**Comments to the Lower Colorado River Authority (LCRA)  
regarding revisions to the 2015 Water Management Plan  
for the Highland Lakes**

**COMMENTS OF THE CENTRAL TEXAS WATER COALITION  
RELATING TO LCRA'S PRESENTATION OF  
ADDITIONAL INFORMATION ON THE UPDATE OF  
ITS 2015 WATER MANAGEMENT PLAN**

Re: Second Round of Comments on 2018 LCRA Water Management Plan Update

## Attachment 1: City of Austin Second Round of Comments on 2018 LCRA Water Management Plan Update – August 24, 2018

Figure 3. Effects of Vista Ridge, End Op, Forestar, and LCRA Power Plant Pumping on Groundwater and Surface Water in the Lost Pines GCD and Post Oak Savannah GCD

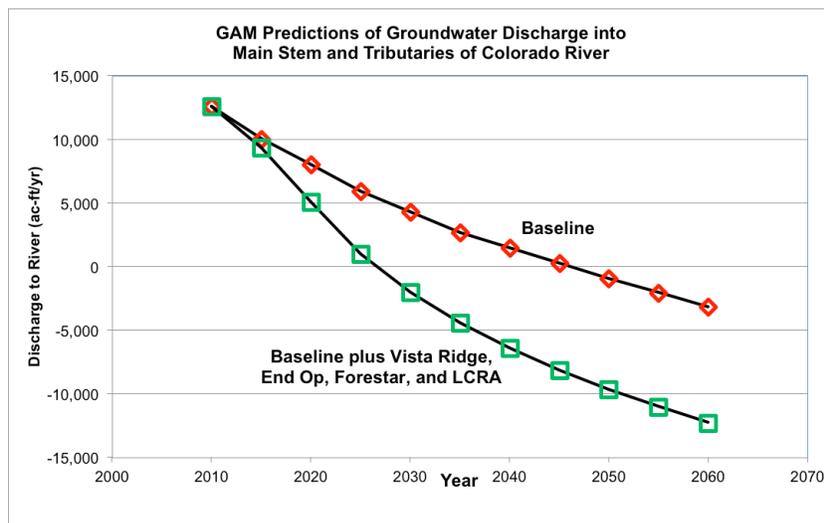
The current groundwater availability model (GAM) predicts<sup>6</sup> that groundwater pumping in the Simsboro Aquifer will affect the Colorado River and its tributaries by decreasing the amount of groundwater that currently go into the river (Figure 3). The model predicts that during the fifty-year planning period both baseline and permitted pumping will cause the river segments in the Utley-Bastrop-Smithville reach to reverse from being primarily a "gaining" stream to become a "losing" stream. This reversal will have a significant impact on environmental flows during dry and extraordinary drought periods, especially if LCRA requests emergency exemptions for interruptible water from the Highland Lakes into the lower basin as was the case during the last drought.

**ES REQUEST 1: Environmental Stewardship requests that the LCRA use the improved GMA-12 GAM to better estimate the impacts of groundwater pumping in the Simsboro Aquifer on the Colorado River and its tributaries in the Austin-Bastrop-Smithville reach to inform the current water management planning process on the potential impacts of such pumping on the overall Highland Lakes system.**

Figure 4. Colorado River at Bastrop gage during drought period Jan.2011 - Dec.2013

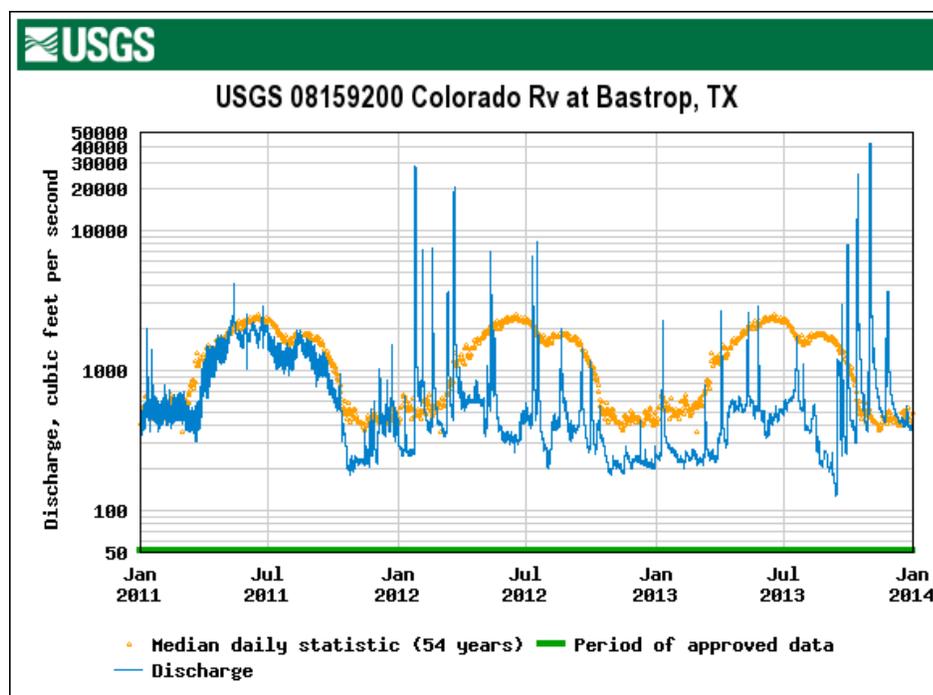
Figure 4 is a hydrograph of the three year drought period from January 2011 through December 2013 when the region experienced some of the most severe drought conditions in decades. The distinguishing feature of this figure is that in-stream flows benefitted from the irrigation releases for down-stream rice farming during the spring, summer, and early fall of 2011. Irrigation water was curtailed during the 2012 and 2013 irrigation seasons. Note, however, that there was very little flow from rainfall during the 2011 period. Lacking irrigation flows, flow in the river for the summer and fall would likely have dropped into the 120 cfs critical environmental flow range during that period.

A hydrograph separation on the three year period represented in Figure 4, with irrigation releases removed, would likely reveal a very good estimate of actual groundwater outflows to the river from the Carrizo-Wilcox Aquifer group. During this period the bank storage for the river had likely been exhausted and the river was relying on the minimum flows passing through the Austin gage at Longhorn Dam, City of Austin return flows, and groundwater base flows. Environmental Stewardship attempted to fund a USGS gain-loss study from Utey bridge to Matagorda Bay during that period to provide current period groundwater outflow estimates for purposes of calibrating GAM and WAM models.

**ES REQUEST 2: Environmental Stewardship requests that the LCRA prepare the hydrographic separation as described above for the period January 2011 through December 2013 for the Bastrop and Wilbarger gages of the Colorado River to gain insights on the quantity of groundwater that was being contributed to river flow for this extraordinary drought period.**

Figure 5. Colorado River at Bastrop gage during drought period Oct. 2012- Sept. 2013

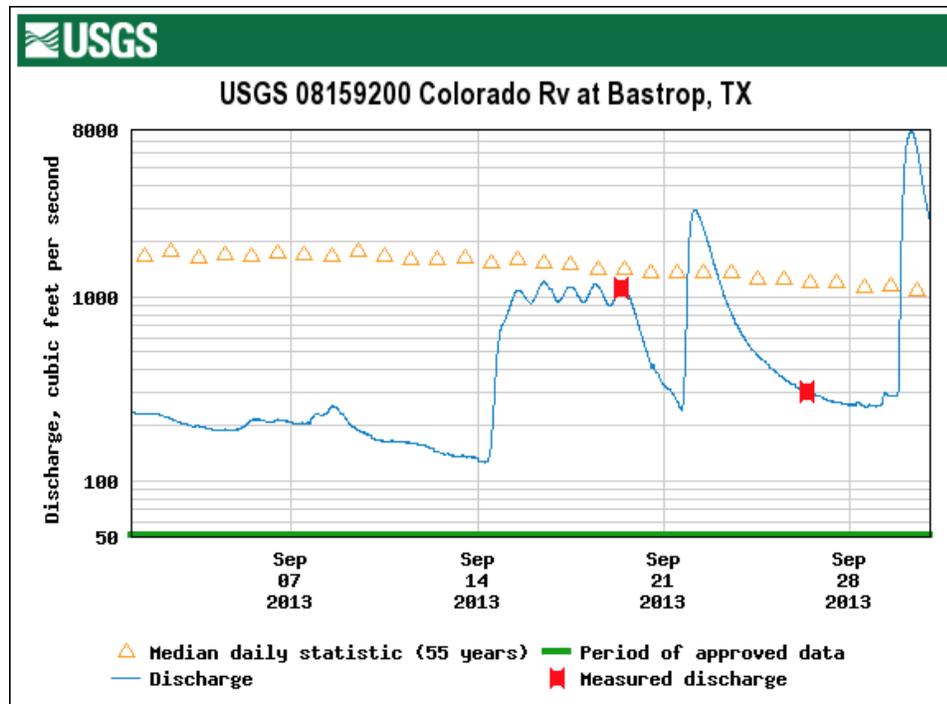
Figure 5 is a hydrograph of the month of September, 2013 when the flow was trending toward the critical in-stream flow minimum. Fortunately, the region received significant rainfall starting in mid-September and river flow rebounded.

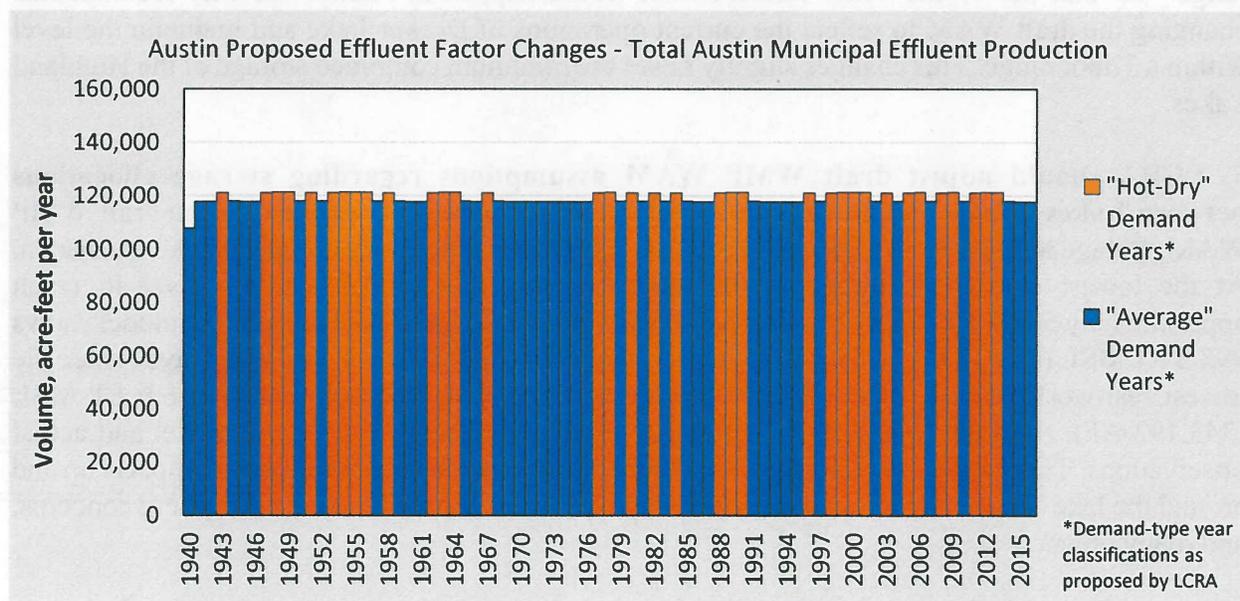
**2. The effluent assumptions in the draft WMP WAM should be adjusted to better reflect actual observed conditions.** In the draft WMP WAM shared with stakeholders, LCRA used a constant effluent production factor for the City for both "hot-dry" and "average" demand years. The constant effluent production factor was based on an average of 2010-2014 actuals. While the City appreciates LCRA's using multiple years to generate an informed effluent production factor, the fact that the effluent production factor is constant creates a situation in the model that is not supported by historical data. Because the draft WMP WAM uses demands fluctuating between "average" and "hot-dry" demands, using a constant effluent production factor results in fluctuating volumes of effluent production in the model, between 112,930 acre-feet per year (AFY) in "average" demand years and 148,630 AFY in "hot-dry" demand years. The graph below shows the total effluent production pattern resulting from LRCA's approach. These large fluctuations are not expected to occur.

Increases in demand during hot-dry conditions tend to be consumptive demands that do not generate effluent, such as cooling and irrigation. Additionally, in "hot-dry" demand years, inflow

and infiltration to the collection system is generally lower and further reduces the amount of effluent generated. Since increased demands do not typically generate a correspondingly larger effluent production and inflow and infiltration is lower in hot-dry years, the total effluent production volume would be expected to not fluctuate significantly between “average” or “hot-dry” demands and conditions. Although the LCRA effluent production factor is based on historical data, it produces results in the WMP WAM that likely could not be expected in a repeat of the 2008-2016 drought.

If this effluent production factor discrepancy is not corrected in the WMP WAM, it can produce results that overstate the water available to meet downstream needs. To correct this discrepancy, the City recommends that LCRA use two different effluent production factors dependent on the demand type (“average” or “hot-dry”) to reflect the variation in effluent production. The City recommends using a 57% effluent production factor in “hot dry” demand years (based on 2011 actuals), and a 71.8% effluent production factor for “average” demand years (based on 2017 actuals). As discussed above, a constant factor applied to two different types of demand conditions (for “hot-dry” and “average” demand years) is not suggested by the City. Additionally, “hot-dry” demand year and “average” demand year effluent production factors based on averages of data from the critical period are not recommended for use over the 77-year period of record due to drought contingency plan implementation and exceptionally large rain events in many of the years in the recent past. Because of the implementation of Stage 2 demand restrictions by Austin in 2012, 2013, 2014, and 2015, these years do not support the best effluent production factors for use in the WMP. Further, 2015 and 2016 are not good representative years due to the occurrence of large rain events leading to higher inflow and infiltration.

The variable percent factors proposed by the City result in significantly less fluctuation in effluent production volume, as shown in the following figure. An Excel file containing the proposed effluent production factors and monthly pattern information will be emailed along with these comments when they are submitted to LCRA. Using the City’s proposed effluent factors addresses the concerns described above.
